Informal document GRE-79-22
(79th GRE, 24 - 27 April 2018,
agenda item 4)

India's comments on underlying principles of approval marking for LSD regulation

Document no GRE-78-35-Rev.1

Proposed Figure

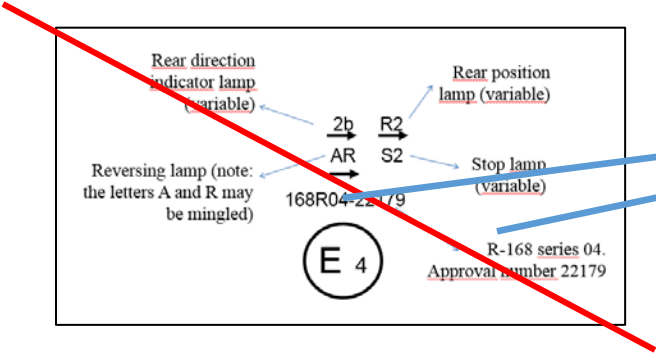
- The marking proposal given in slide 2 of GRE-78-35 Rev. 1 (below) may be replaced by the following figure :

Series of amendment mandatory as per 1958 agreement Rev 3 , In this figure it can be linked to change index See table in Sr No 2

Marking UNECE R no is not mandatory ...see Annex 1 (Item no 1)
